Access Compliance Report Public Rights-of-Way (Curb Ramps)

Intersection ID: 5916 Main Street: FAIRES_FARM_RD Cross Street: HANBERRY_BV Location: NW

ADA ID: 7EF793909FBD Ramp Type: PerpDiag Initial Pass/Fail: Fail Overall Compliance: No Severity Score: 46.25

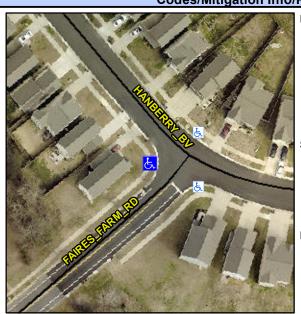
Not Found, R304.5.1, R304.2.2, R304.5.3

| Field Measurements/Component Compliance | | | | | |
|---|-----------------------|-------|------|-----------------------------|-------|
| N/A | Ramp Length (in) | 70.0 | No | Ramp Slope (%) | 11.2 |
| No | Ramp Width (in) | 47.0 | No | Ramp XSlope (%) | 7.0 |

Remove & Replace Curb Ramp With Two New Directional Ramps or Equivalent.
